From: ROHAN helyar <rhelyar16@bigpond.com>
Sent: Friday, 14 December 2018 9:17 AM
To: Carlo Scinto
Subject: Re: RE: 2-4 Woodmere Ave Paradise: Stage 1 footing application
Attachments: HG0556C Model (1).pdf

I have been requested by one of your clients to pass on these queries for Building Rules Consent to you regarding your drainage design

For stage 1 — footings & siteworks
purposes only

TITLE: **FOOTING PLAN**
ADDRESS: **NO.2-4 WOODMERE AVENUE**
PARADISE

External steps.

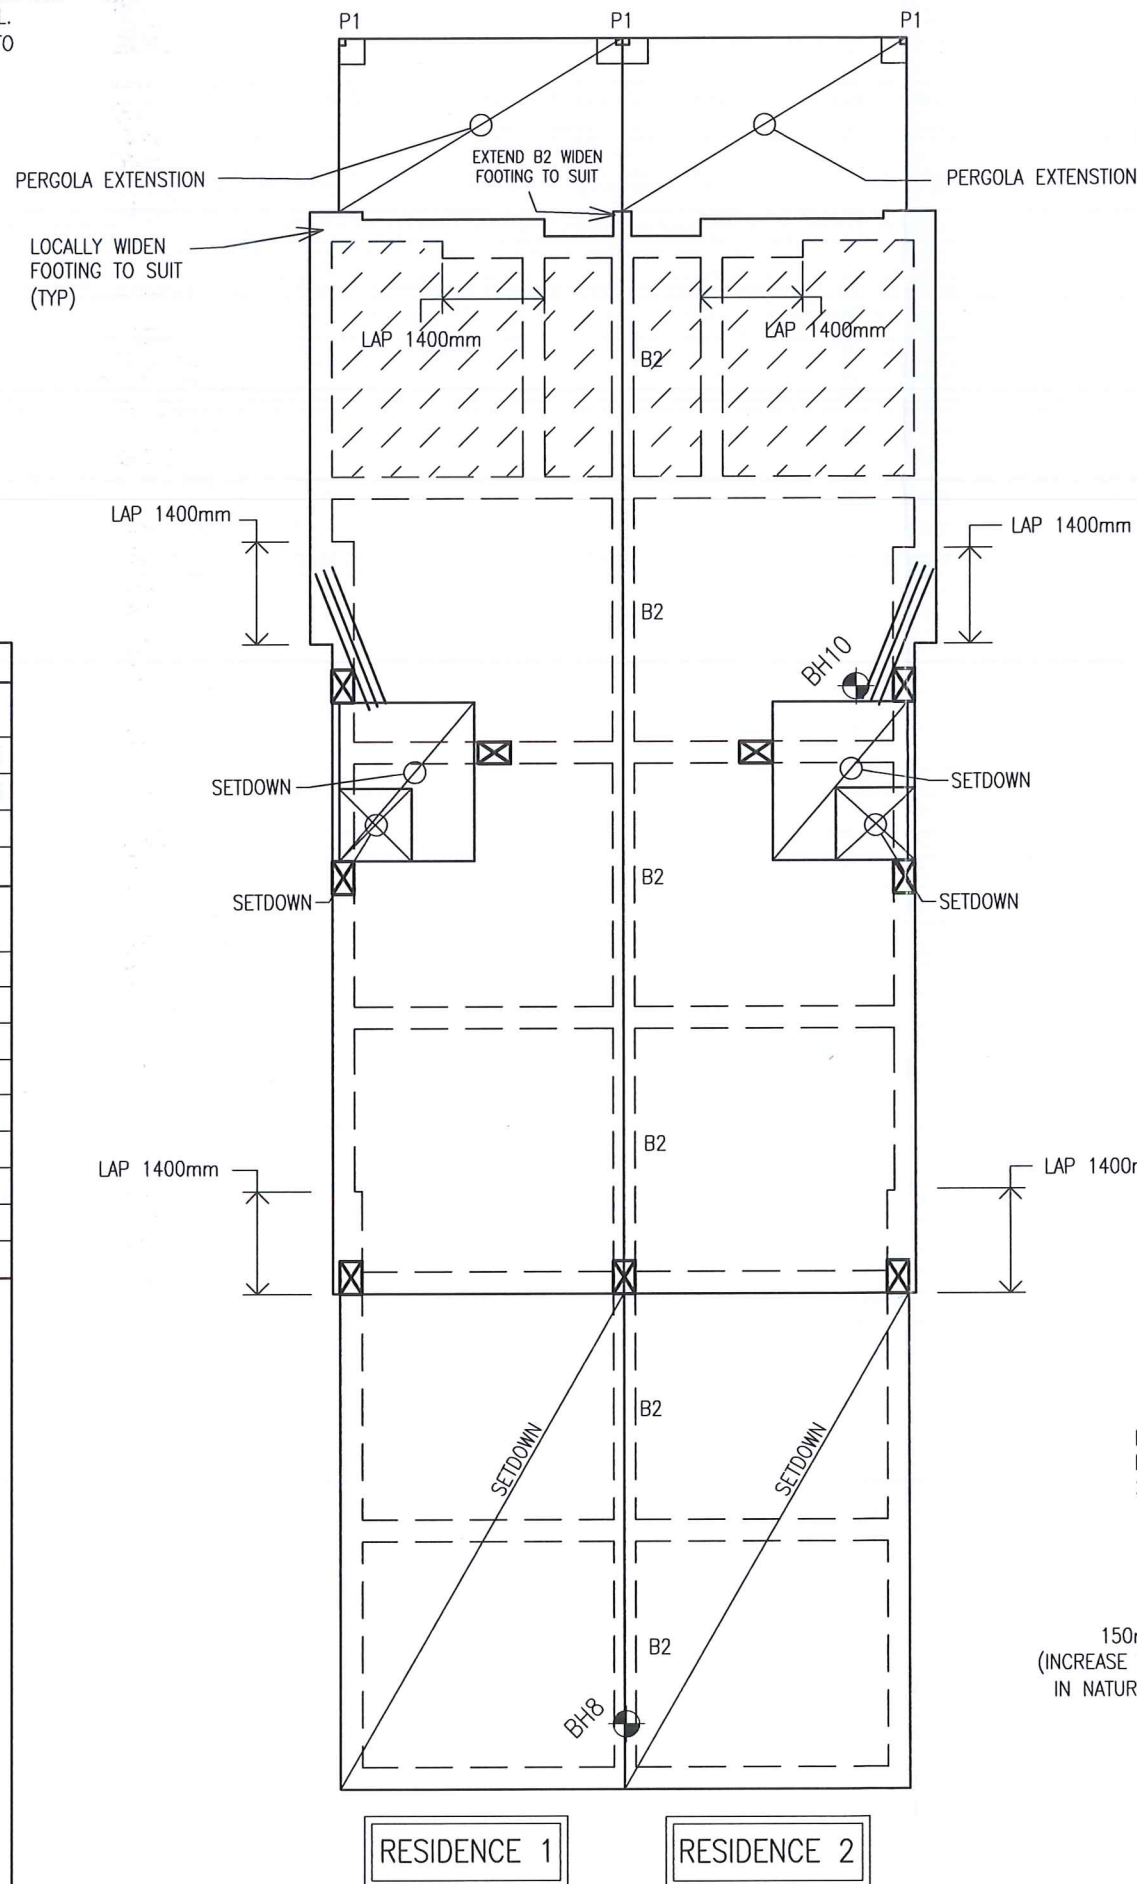
2. External step details adjacent Woodmere Avenue, including:
 - The going length and riser heights
 - The slip resistance requirements to all steps and landings
 - The construction details of the steps (I assume the steps will be solid with no openings??)

1) The concrete steps can be built by just following the ground or batter. As they are external to the building, we can consider that the steps can be built using the details in accordance with our paving detail sheet PD1 and paving requirements in our footing general notes (and AS 3721.1 - 2006 - Guide for Residential Pavements) adequate. The steps above the paving slab can be formed in mass concrete over.

- Going length = 300mm
- Riser height = 180mm
- Slip resistance classification is accordance with Table 3.9.1.3 of NCC - 2016.
